CITY OF KETCHUM, IDAHO

DATE: March 8, 2024 ADDENDUM NO. 1

Idaho Project No. A022(210) SH-75, Main St, Ketchum Blaine County, Key No. 22210

NOTICE TO PLANHOLDERS:

SIGNAL PLANS SH-75 - MAIN ST KETCHUM FOURTH ST

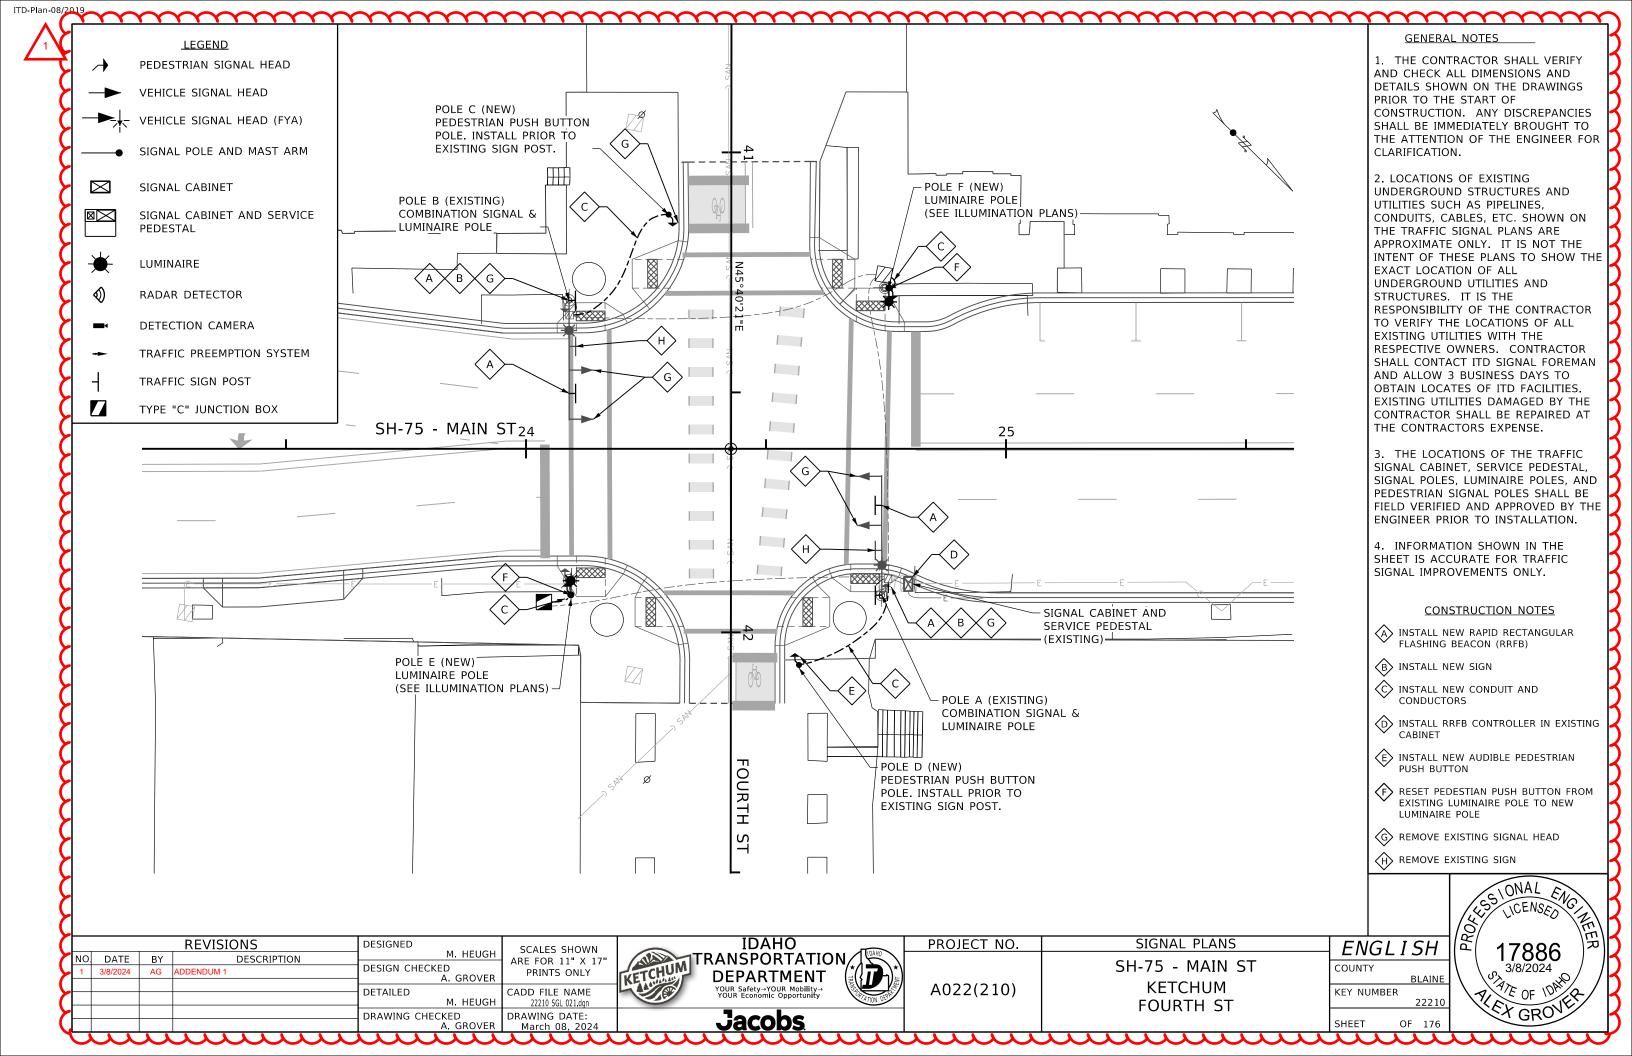
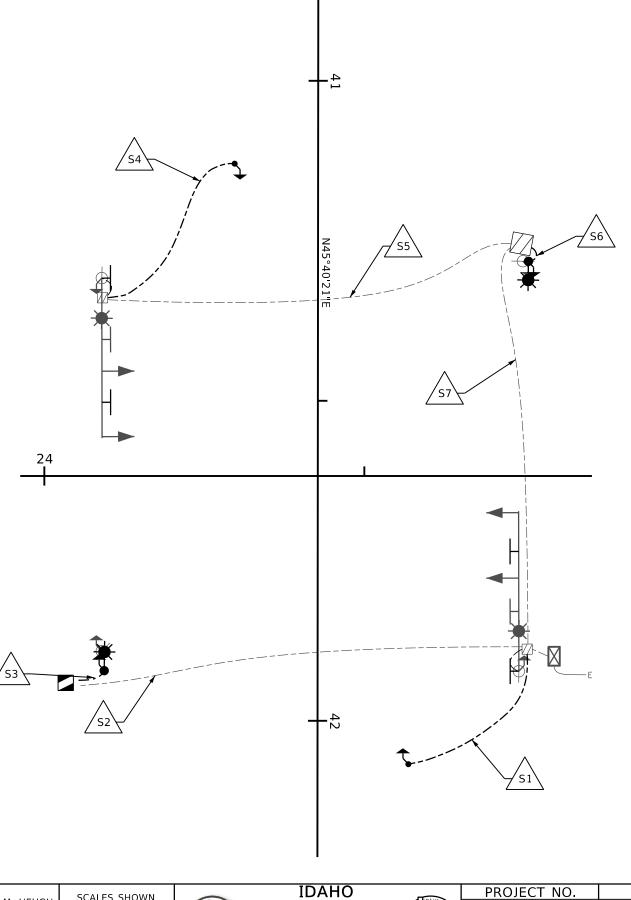
- ADD Two (2) New Sheets representing Additive Alternative 2: Fifth Street Sidewalk Infill and Bulbout.
- REPLACE plan sheets 121, 127, 133, and 139, make changes as indicated in attached modified sheets representing new work to replace the existing HAWK with an RRFB system.
- INSERT Four (4) New Sheets after Sheet 138 representing RRFB (sheet numbering to be adjusted in Conformed Drawing set).
